# Access Compliance Report

## Public Rights-of-Way

### (Curb Ramps)

Intersection ID: 3180	Main Street: JOHNSTON_OEHLE_R_D	Cross Street: SONG_SPARROW_LN	Location:	S
ADA ID: F3FA3788974F	Ramp Type: Perp	Initial Pass/Fail: Fail	Overall Compliance: No	Severity Score: 25
Codes/Mitigation Info/Possible Solution		Field Measurements/Component Compliance

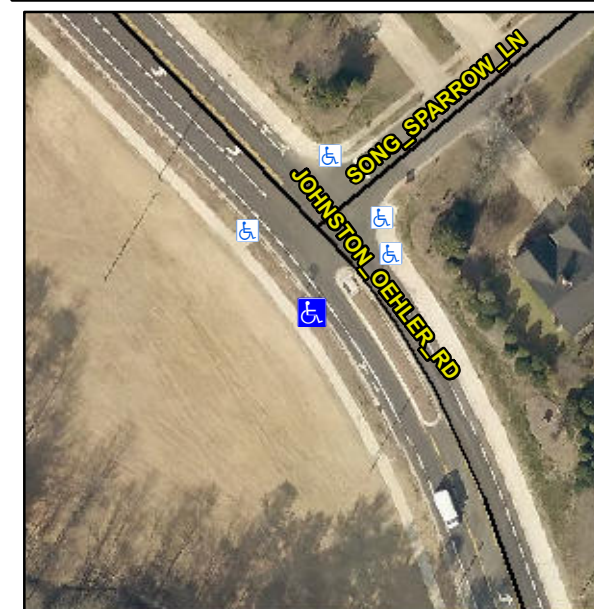
**R304.2.2**

Compliance	Description	Data	Compliance	Description	Data
N/A	Ramp Length (in)	95.5	No	Ramp Slope (%)	13.2
Yes	Ramp Width (in)	95.0	Yes	Ramp XSlope (%)	1.5
N/A	Flare Type LT	N/A	N/A	Flare Type RT	N/A
N/A	Flare Slope LT (%)	N/A	N/A	Flare Slope RT (%)	N/A
N/A	Flare Traversable LT?	N/A	N/A	Flare Traversable RT?	N/A
N/A	Landing Length (in)	N/A	N/A	DWS Provided?	N/A
N/A	Landing Width (in)	N/A	N/A	DWS Contrast?	N/A
N/A	Landing Slope (%)	N/A	N/A	DWS Length (in)	N/A
N/A	Landing X Slope (%)	N/A	N/A	DWS Full Width?	N/A
N/A	Landing Curb? (Y/N)	N/A	N/A	DWS Offset (in)	N/A
N/A	Shared Landing?	N/A			
N/A	Gutter Ponding?	N/A	N/A	Gutter Slope (%)	N/A
N/A	Gutter Lip Ht (in)	N/A	N/A	Gutter X Slope (%)	N/A
N/A	Painted X Walk1?	No	N/A	Painted X Walk2?	N/A
	X Walk 1 Direction	To NE		X Walk 2 Direction	N/A
N/A	X Walk 1 Width (in)	N/A	N/A	X Walk 2 Width (in)	N/A
	X Walk 1 Slope (%)	1.4		X Walk 2 Slope (%)	N/A
	X Walk 1 X Slope (%)	1.3		X Walk 2 X Slope (%)	N/A

**Remove & Replace Entire Ramp.**
